Avani Environmental 95 Cypress Drive Youngsville, NC 27596 P# 919-570-2862 F# 919-570-2863		
Project: RJ Automation		
Drawing: RM-6000 Roll System		
Date: 4/10/13	Drawn by: WWB	
Sheet No: 1 of 1	Rev.: 0

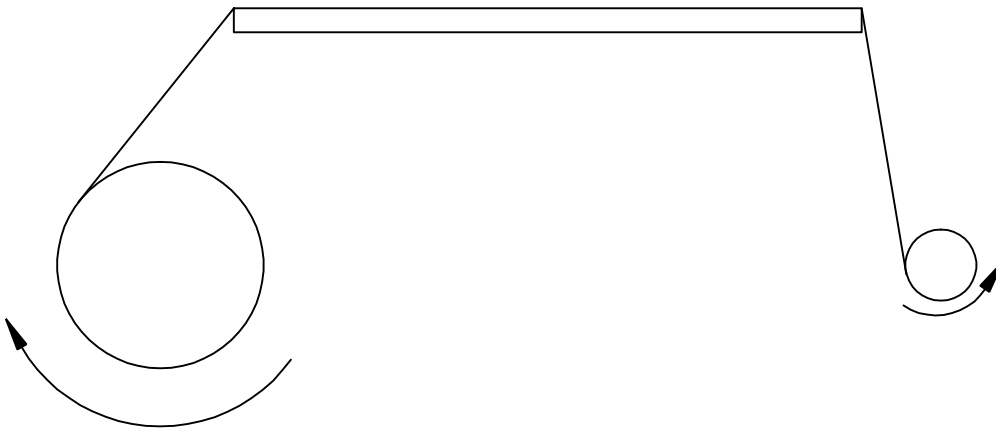
This is how the tech manual shows the roll media loaded and how it feeds and is taken up.

This is how the unit operates in the field. Is this a problem?

The steel rod that is on the collection side will not stay in place with this operation. Do we need to change the rotation direction of the collection motor and if so, how do we change the rotation.
